**ADDENDUM  
NO. 01**

**February 14, 2024**

**Addition and Renovations to Franklin Central High School Phase 2A  
6215 S. Franklin Rd  
Indianapolis, IN, 46259**

This Addendum consists of Pages ADD 1 – 1 through ADD 1 -5, Guideline Schedule and attached VPS Architecture Addendum No. 1 dated February 14, 2024, consisting of 2 pages, Specification Section 08 71 00 – Door Hardware, 23 82 39.16 Propeller Unit Heaters and 8 Addendum Drawings.

**SIDEWALK REQUIREMENT**

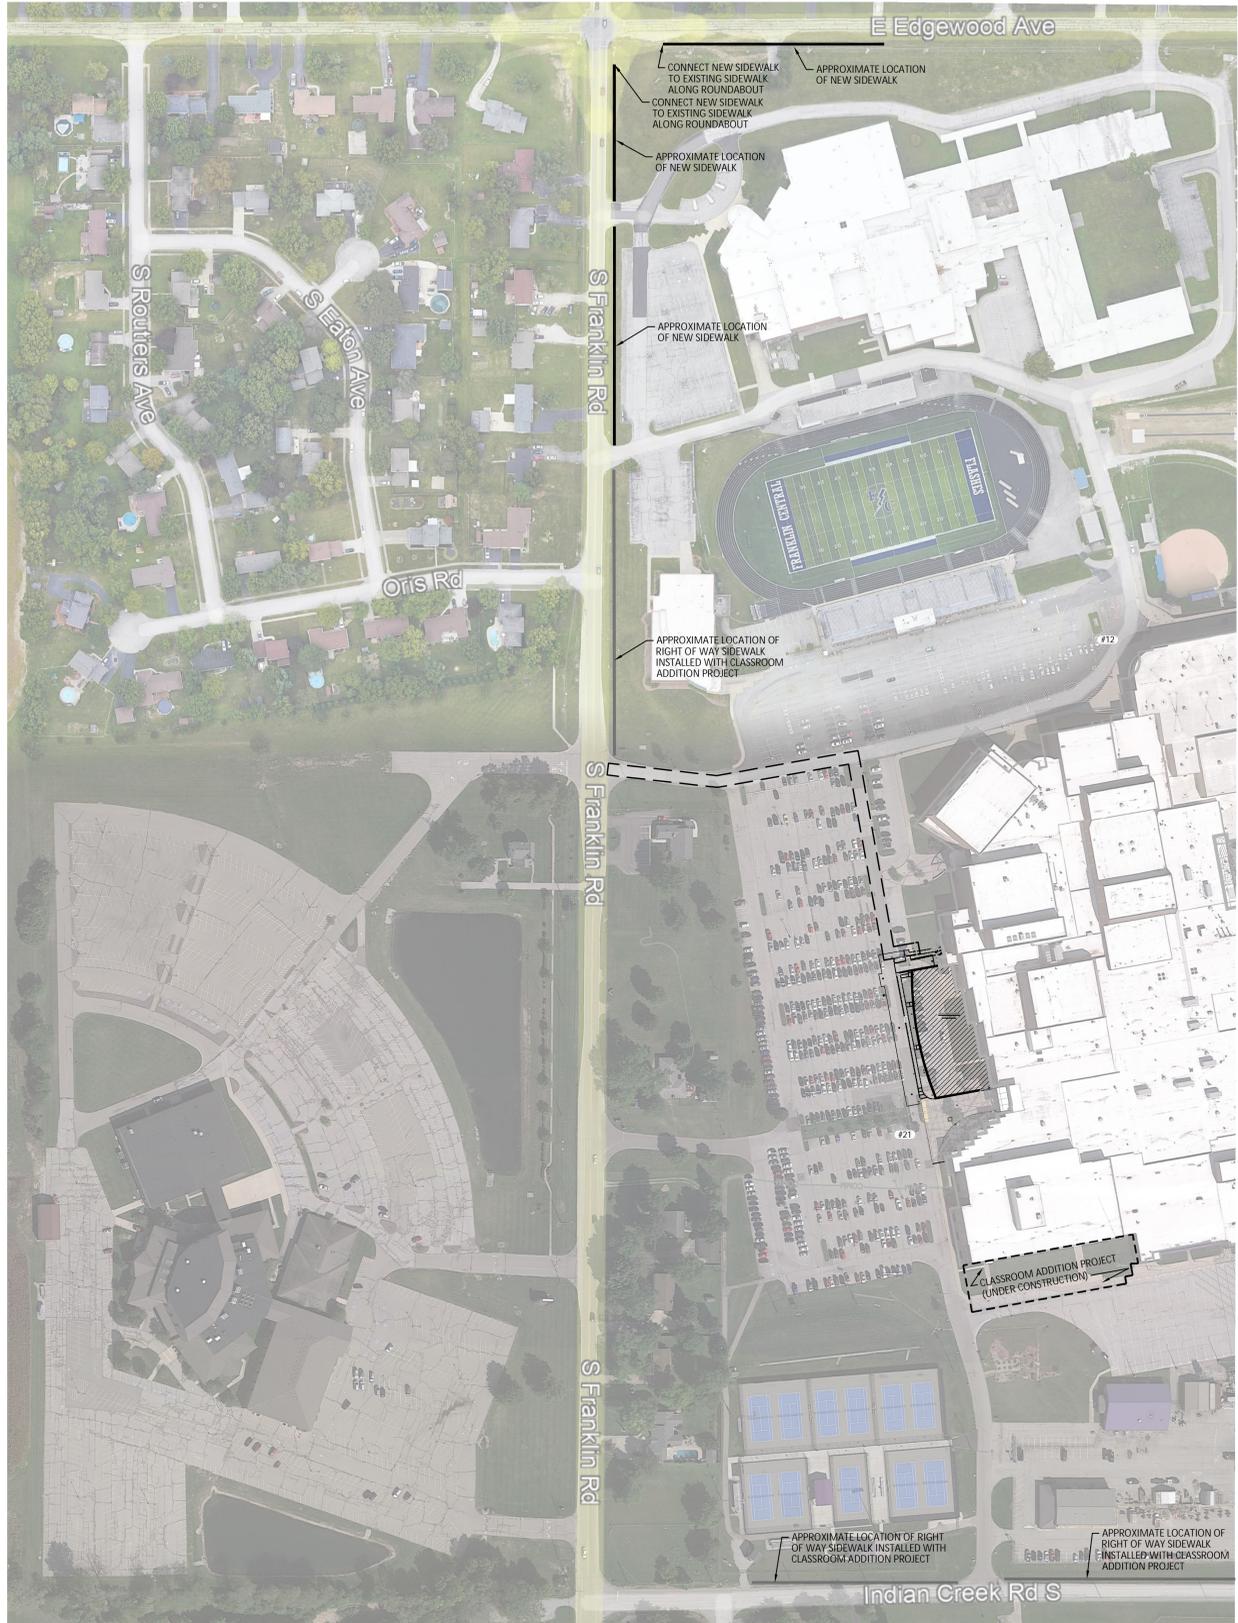
AS PART OF THIS PROJECT CONTRACTOR TO CONSTRUCT A MINIMUM OF 984 LF OF 6' WIDE SIDEWALK IN THE RIGHT OF WAY ALONG THE SOUTH FRANKLIN ROAD OR E EDGEWOOD AVE FRONTAGE ON PROPERTY OWNED BY FRANKLIN TOWNSHIP COMMUNITY SCHOOL CORPORATION PER SECTION 744-304 OF THE MARION COUNTY CODE OF ORDINANCES. EXACT LOCATION OF SIDEWALK TO BE COORDINATED WITH THE OWNER. APPROXIMATE LOCATION OF SIDEWALK IS SHOWN ON THE PLAN. CONTRACTOR TO FIELD VERIFY LOCATION AND ROUTING WITH EXISTING CONDITIONS ALONG FRANKLIN ROAD AND INDIAN CREEK RD'S. CONTRACTOR TO PROVIDE ACCESSIBLE RAMPS COMPLYING WITH INDIANAPOLIS DPW STANDARDS AT EACH INTERSECTION AND DRIVEWAY.

**HYDRONIC PROP UNIT HEATER SCHEDULE NOTES:**

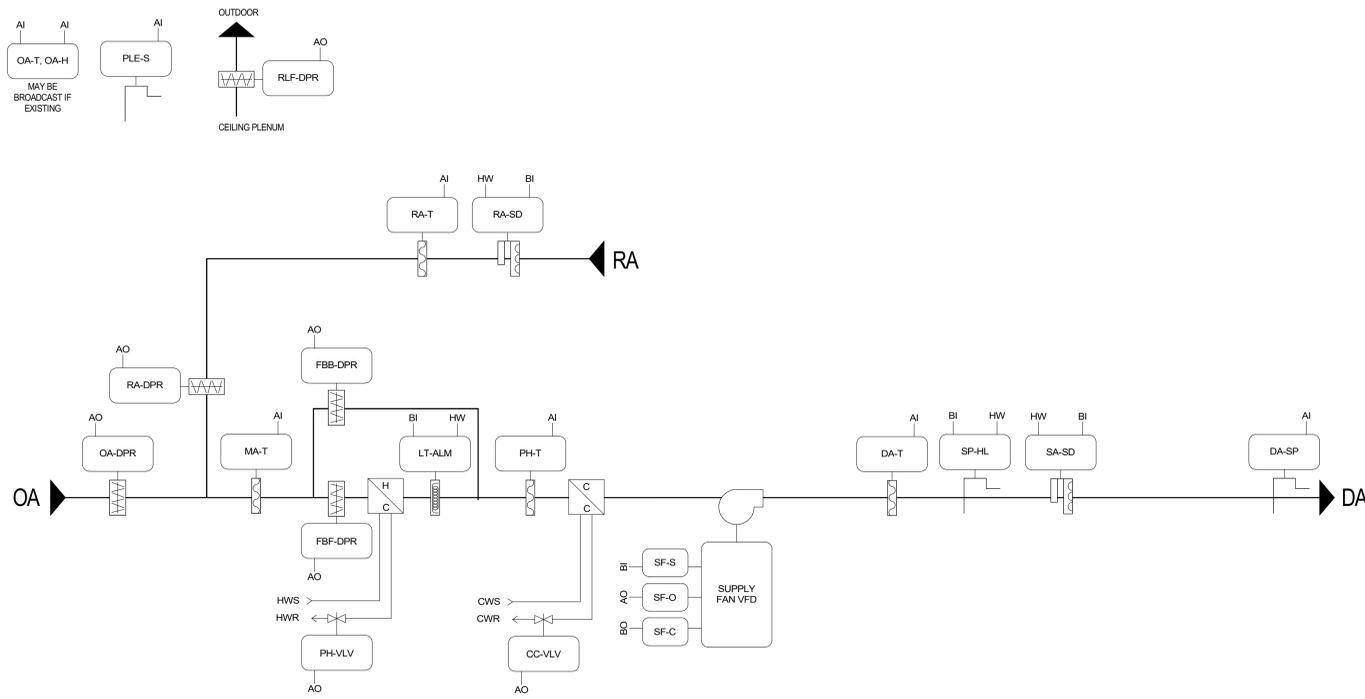
1. PROVIDE WITH SPEED CONTROLLER
2. MC TO PROVIDE ALL REQUIRED HANGERS AND SUPPORTS.
